Addendum No. 4

TANK ACCESS ROAD IMPROVEMENTS

PWP Bid No.: WA-2019-070
TMWA Capital Project No.: 14-0015
January 4, 2019

SHEET NUMBER
C9
 11 OF 12

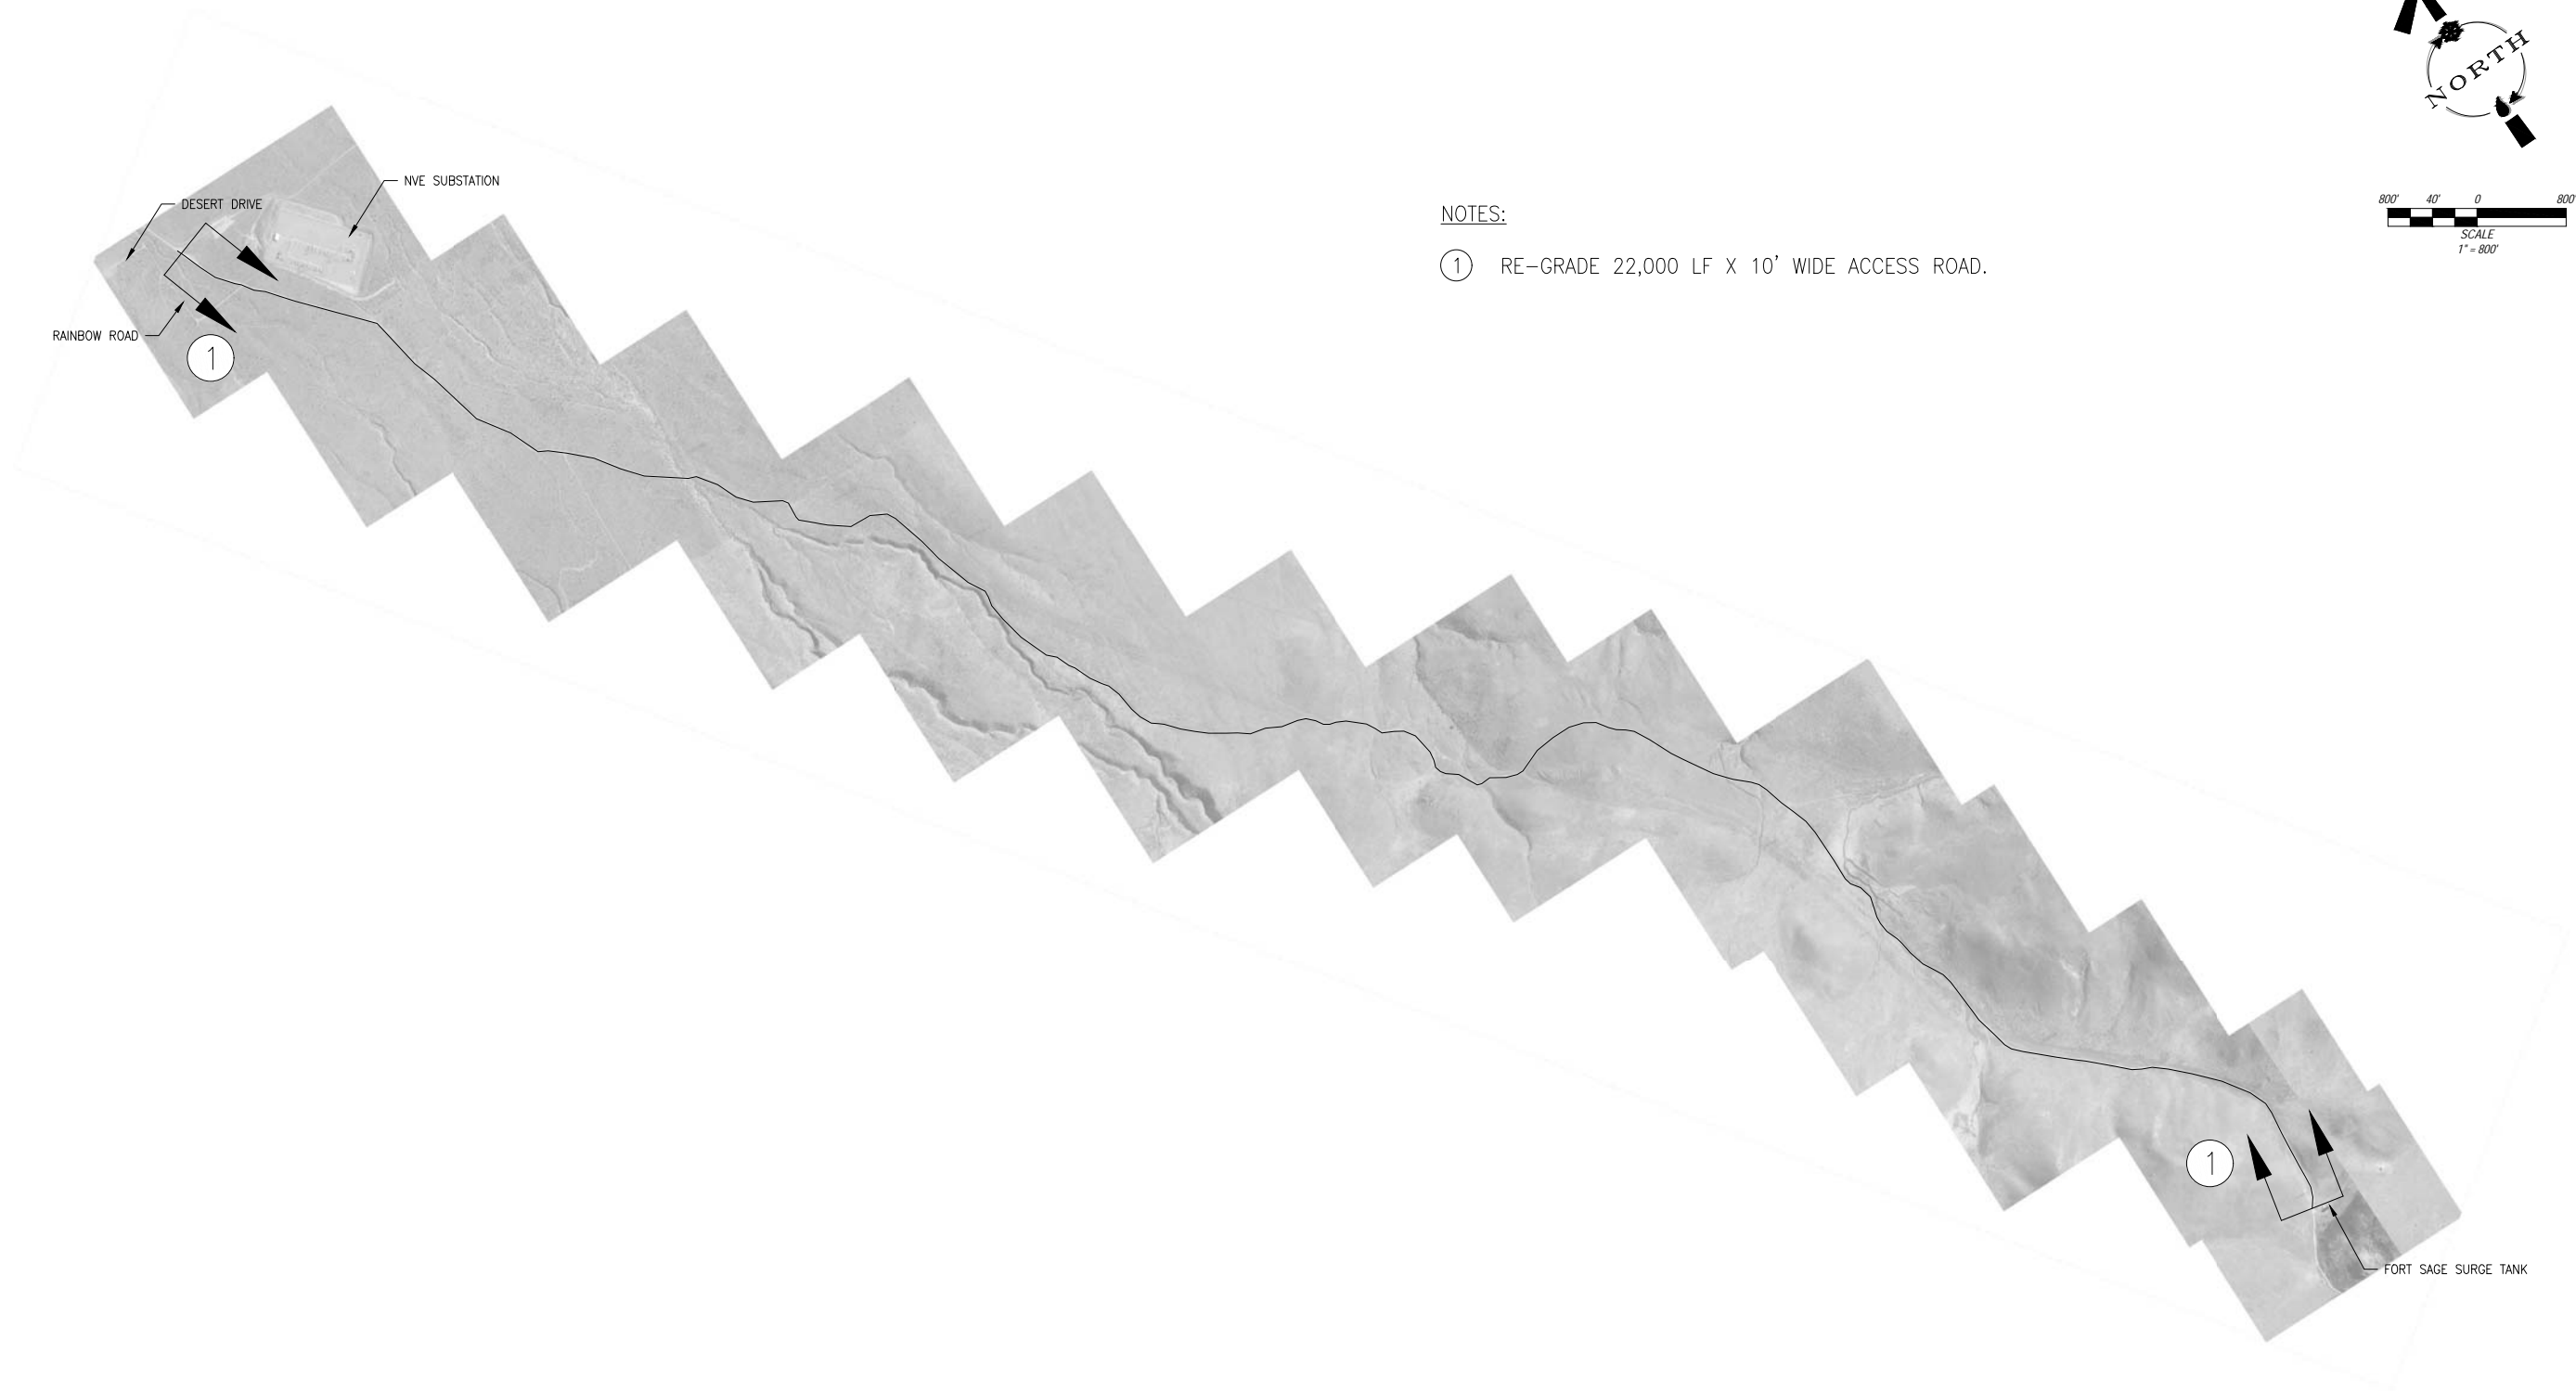
The road with indicated in Note 1 on Sheet C9 of the Improvement Plans is incorrect. The note has been corrected, and the revised sheet is attached. Bidders are directed to remove Sheet C9 from the Bid Set and replace it with the attached, corrected sheet.

- ① RE-GRADE 22,000 LF X 10' WIDE ACCESS ROAD.
